**REVISED  
SCHEME DRAWING**

**2010 / 1C**

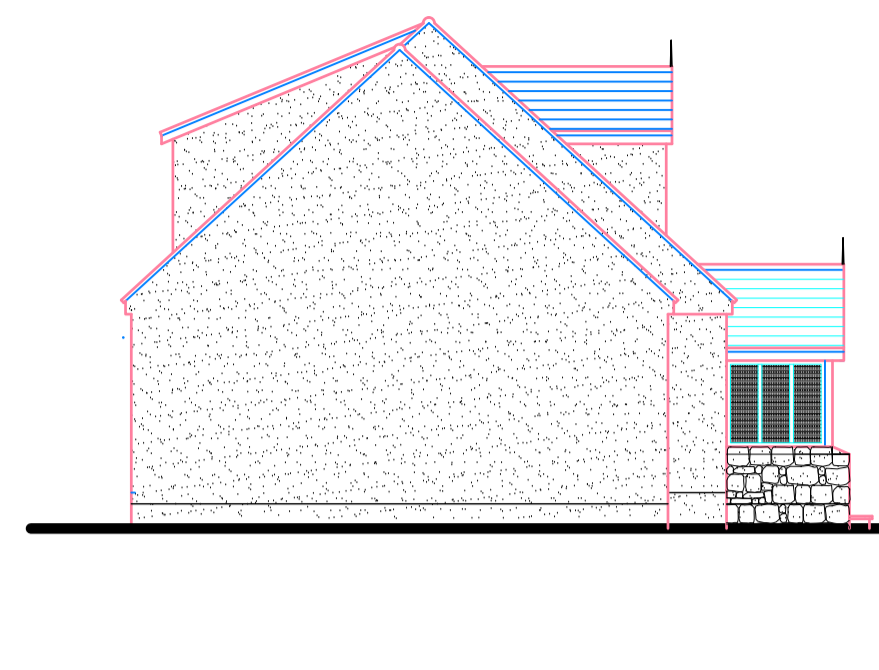
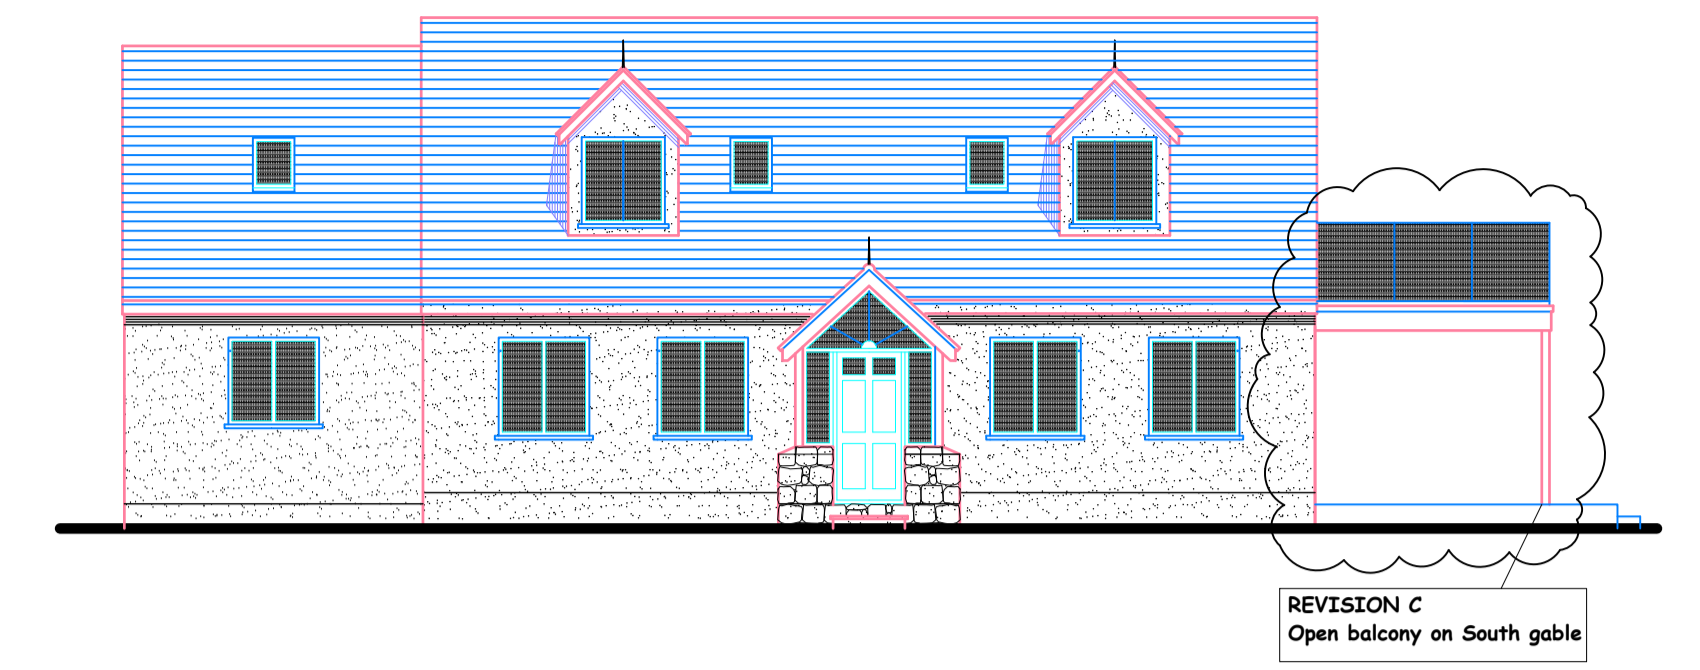
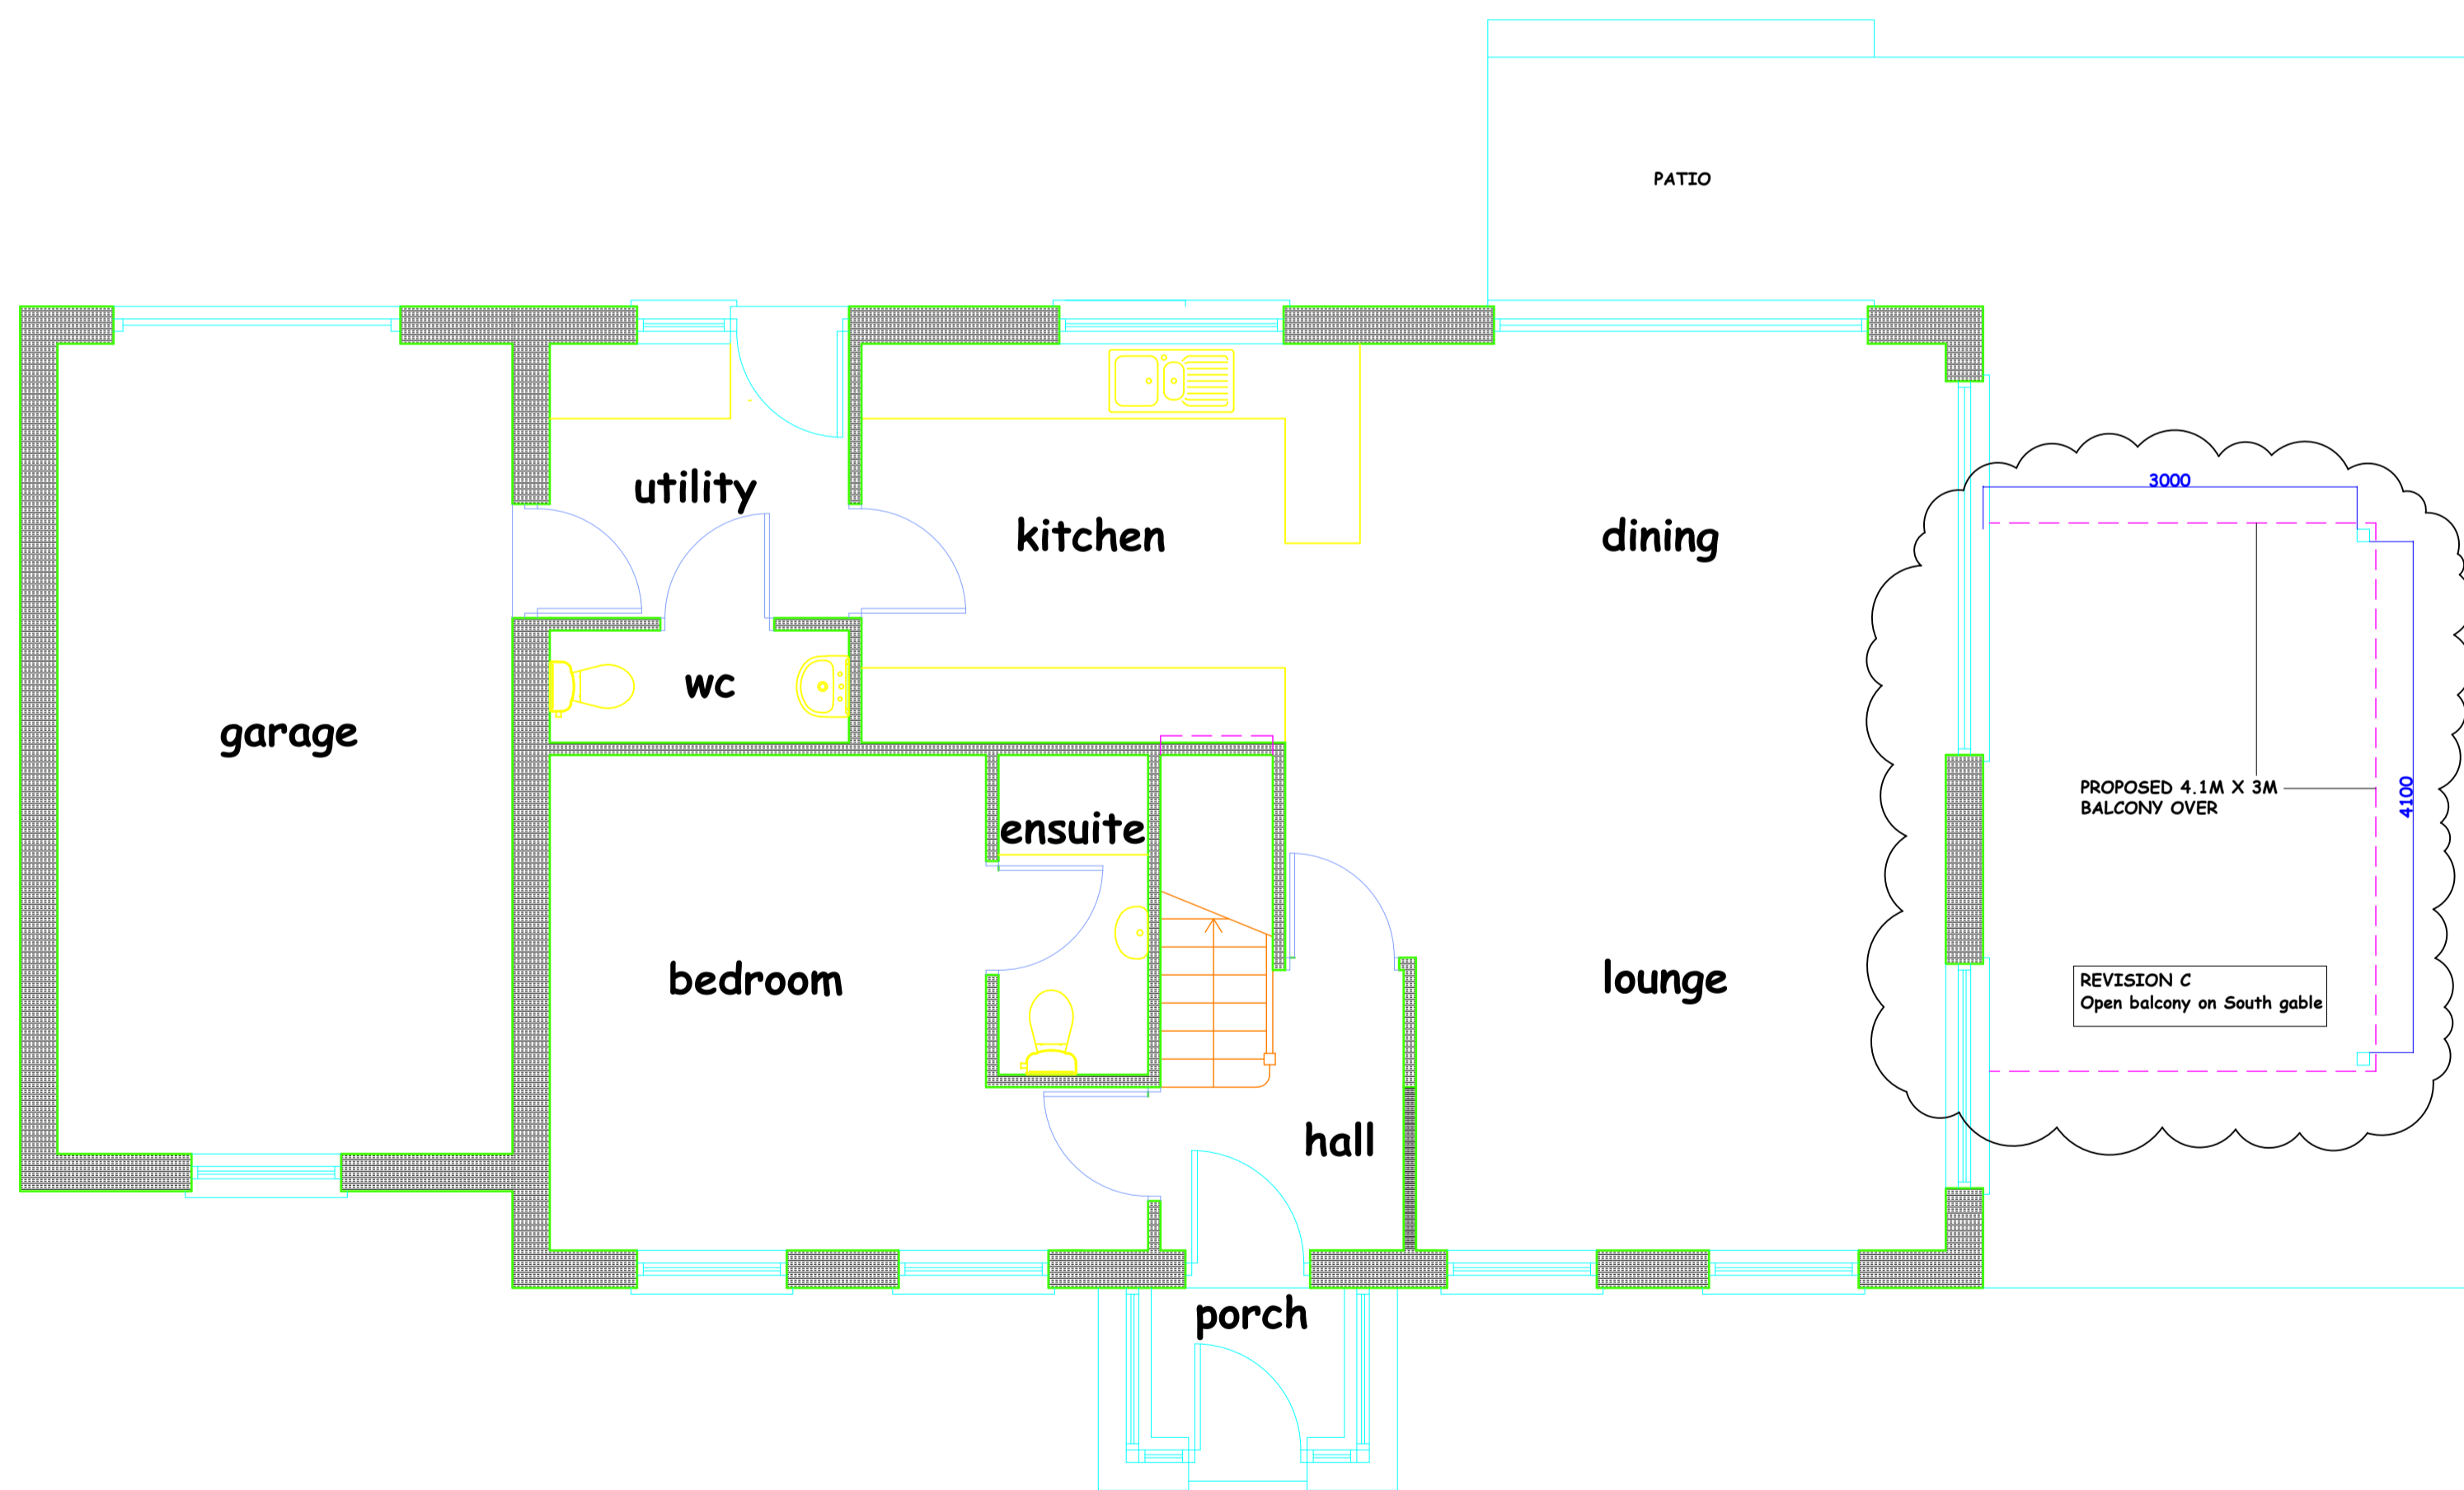
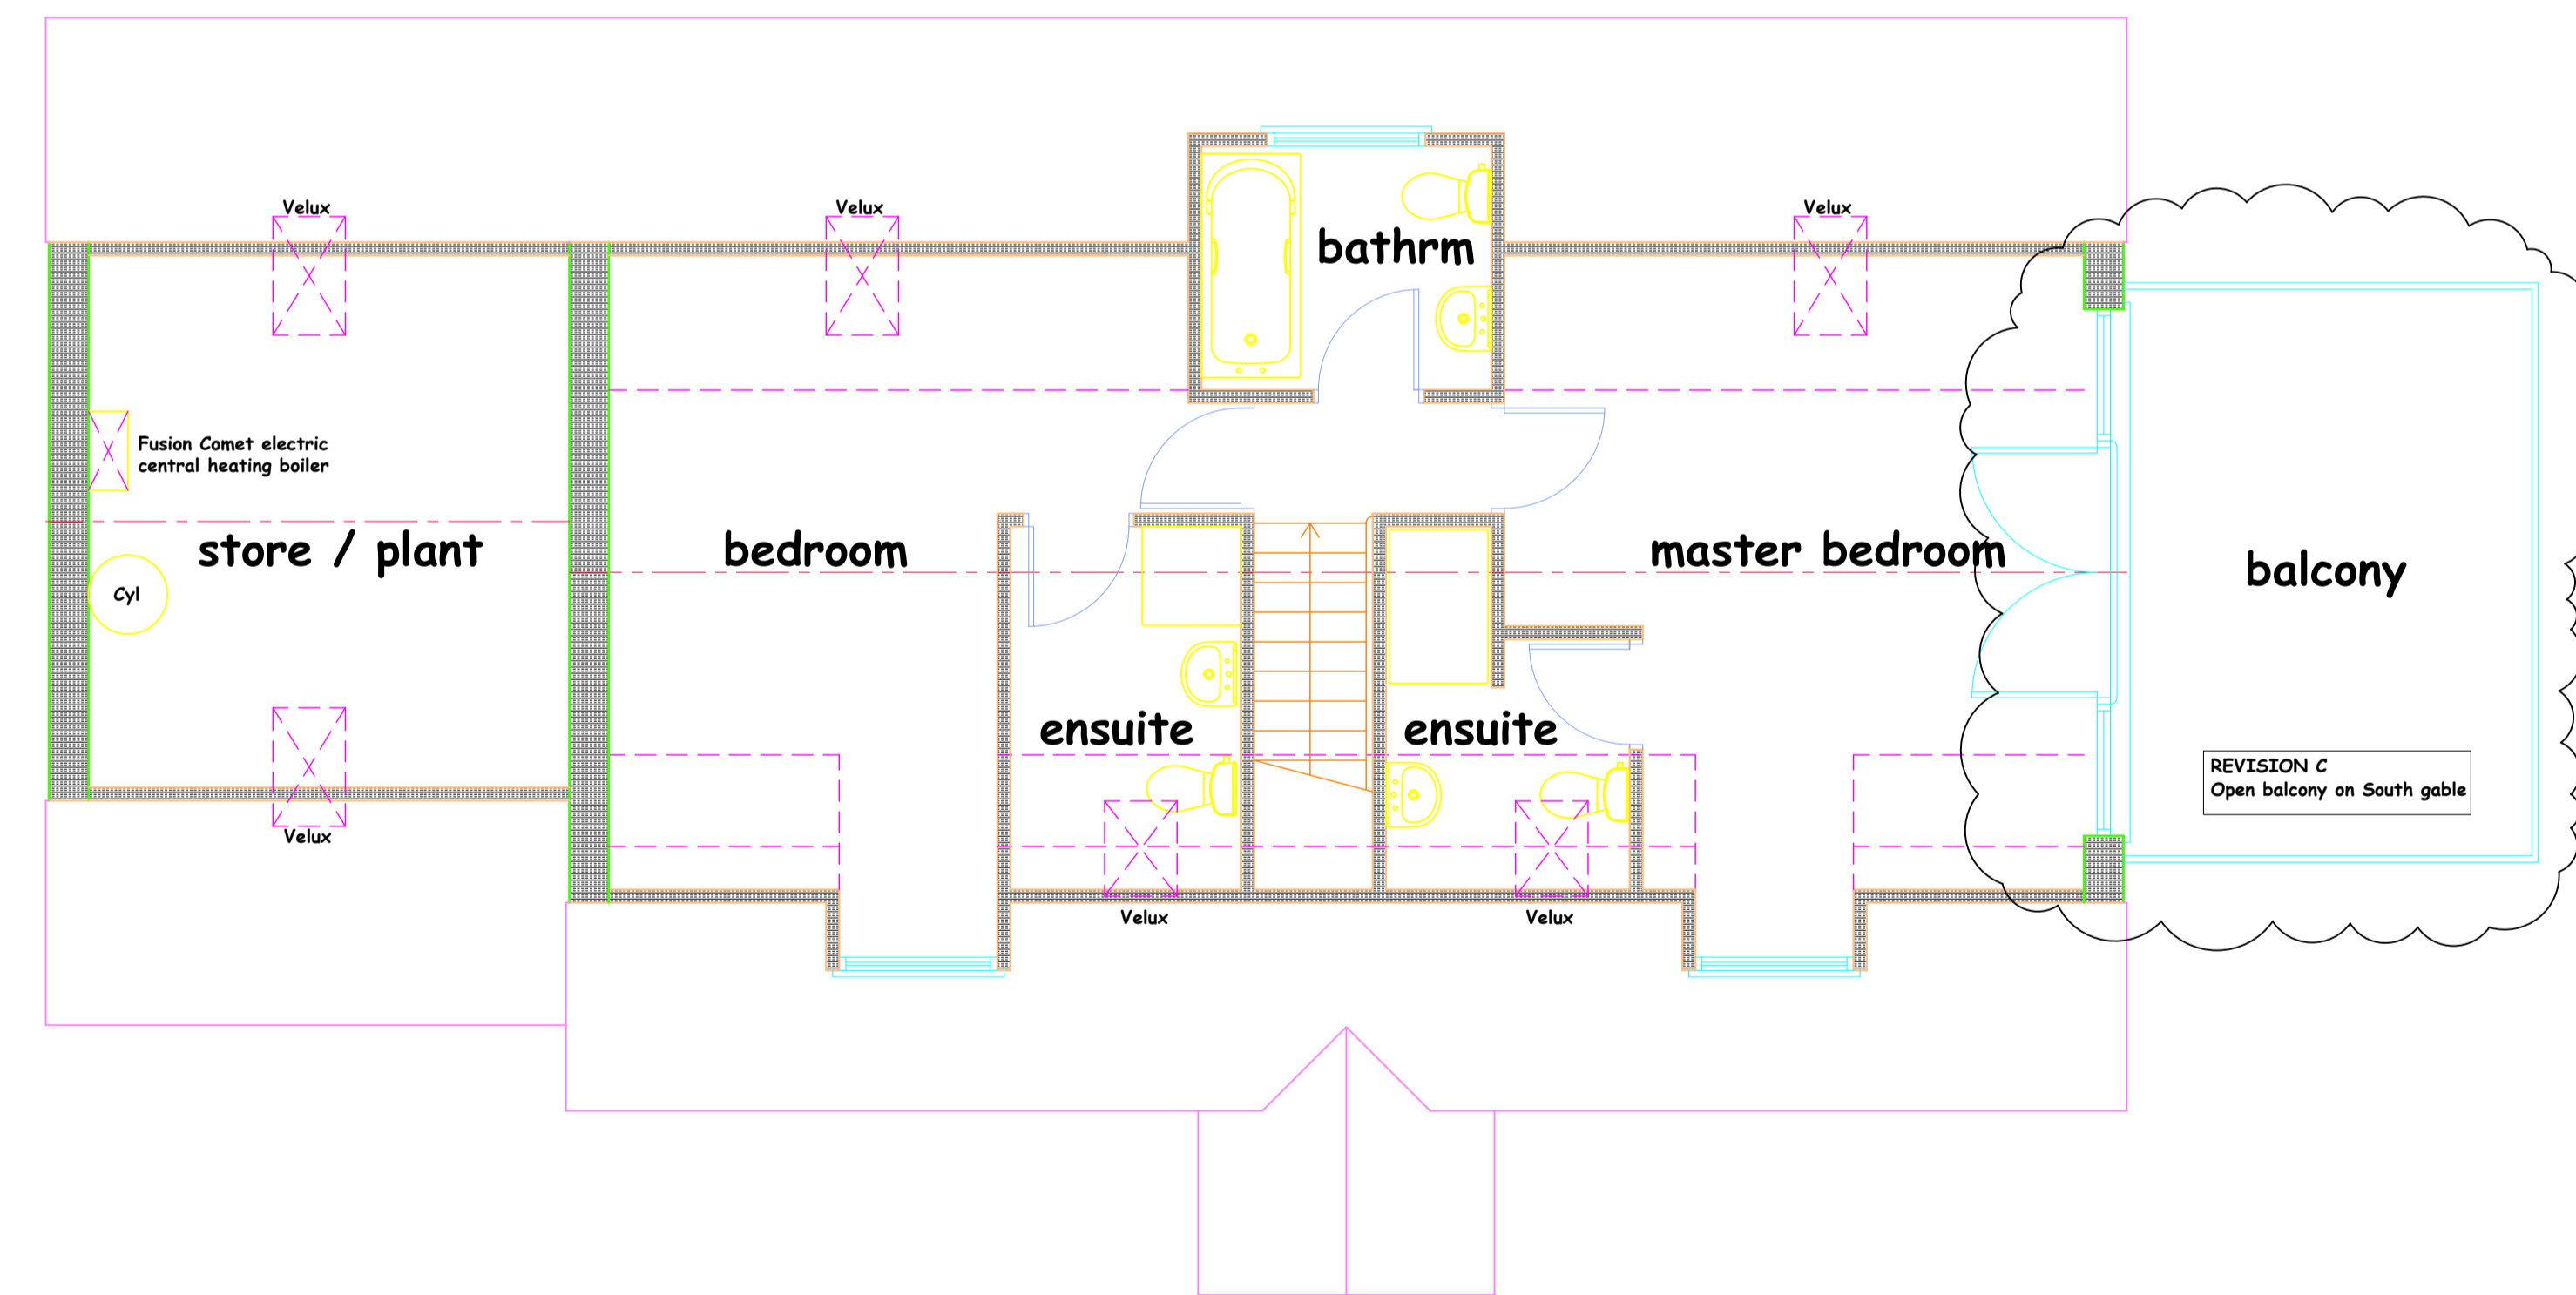
- REVISIONS**
- A) Drawings revised to reflect :-
  - ① Dwelling raised by 150mm as coastal location flooding counter measure
  - ② Dwelling repositioned slightly to allow working room around existing dwelling which will be demolished straight after completion of the new dwelling.
  - ③ Front Velux rooflights moved apart slightly for ease of construction.
  - ④ Drive to rear amended to comply with Part M of the G.T.S. - Access for the disabled.
  - B) Drawings revised to reflect dressed granite sill to Porch.
  - C) Drawings revised to reflect first floor balcony addition to South gable
